Landscape Analysis to support the Response to the Inspector's Advice Note

WYG/ A088250-2

### **Cherwell District Council**

### Site LSCA51/PR9

**Illustrative Plan**

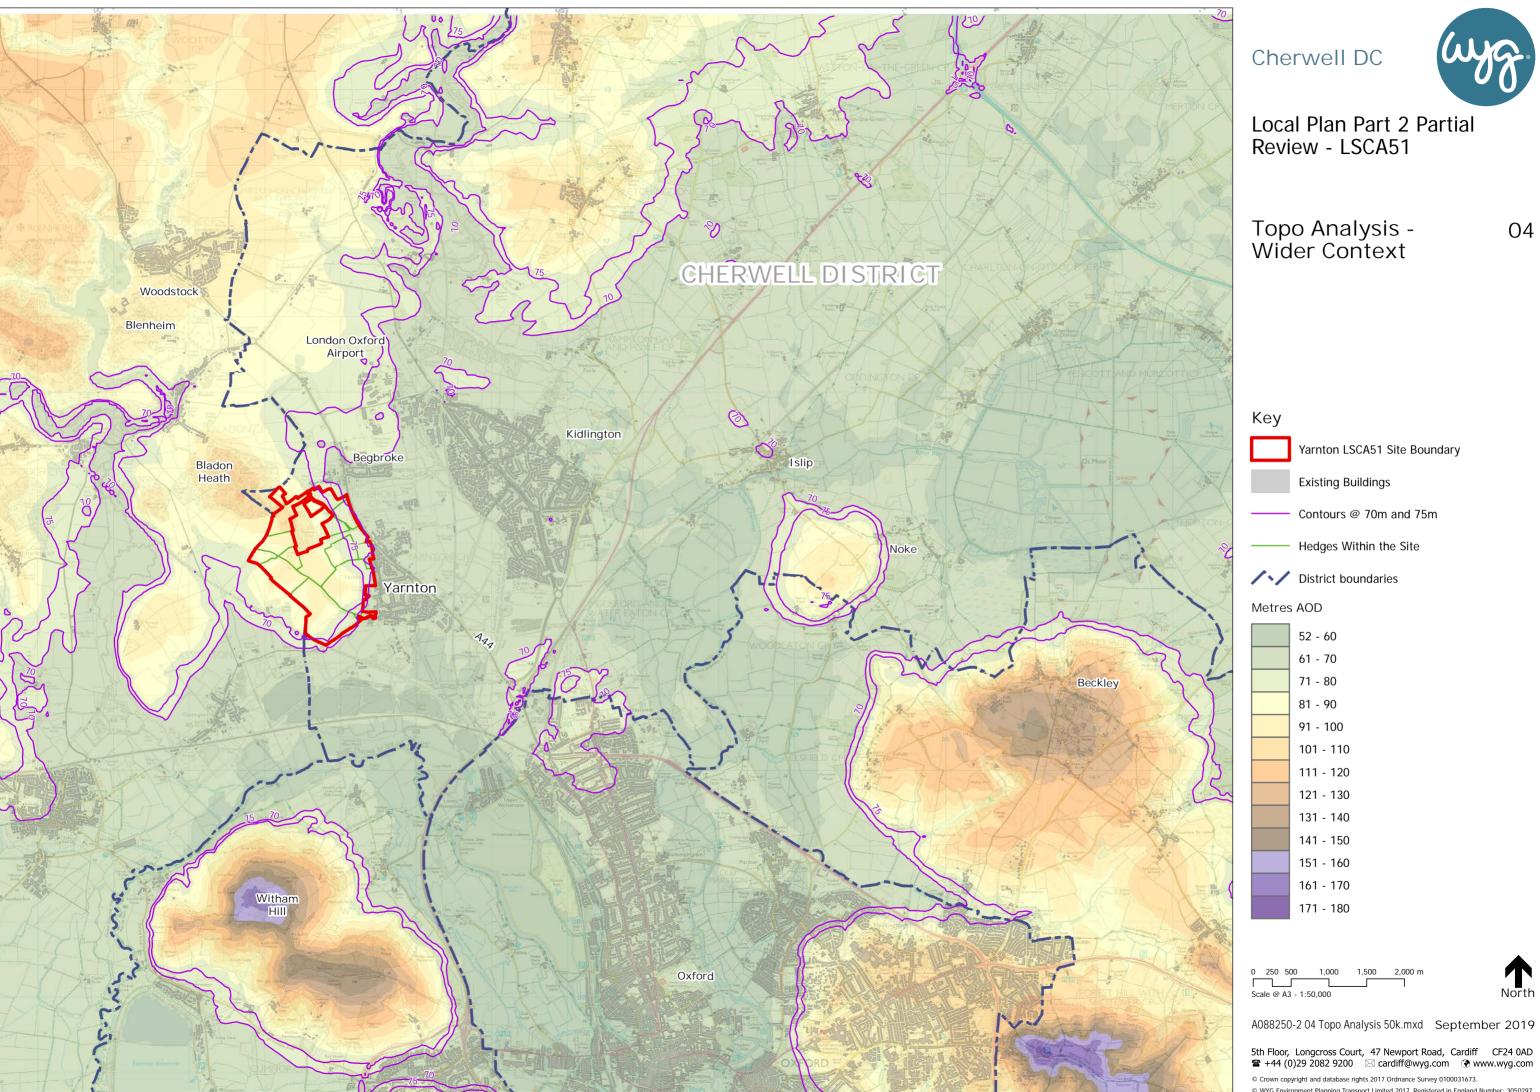
- a footpath along the eastern edge of the playing field connecting the northern access to the car park.
- A3.3 The existing land is sloping down approximately west to east to rear boundaries of existing houses on Rutten Lane. The levels at the rear boundaries to the houses are indicated as close to the existing levels, within about 0.5m. Cutting into the landform would be needed to achieve the proposed levels. This is indicated on the plan by banking "no greater than 1:3 with 1m wide level area" to the fence between the playing field and the access road corridor.

for any e.g. tree planting between the road and playing field, although greater space is allowed to the west of the road where planting could take place. Given the continuous boundary between the road and the playing field, and the overall road corridor being rather narrow, this element of any scheme would need careful consideration. The personal safety of pedestrians using the footways also needs to be considered. Street lighting is likely to be required.

A3.8 The recommended main playing direction is approximately north (between 285° and 20°) / south, to minimise the effect of a setting sun on the players<sup>11</sup>. The illustrative plan shows an approximate orientation of a little west of north, and within the recommended range.
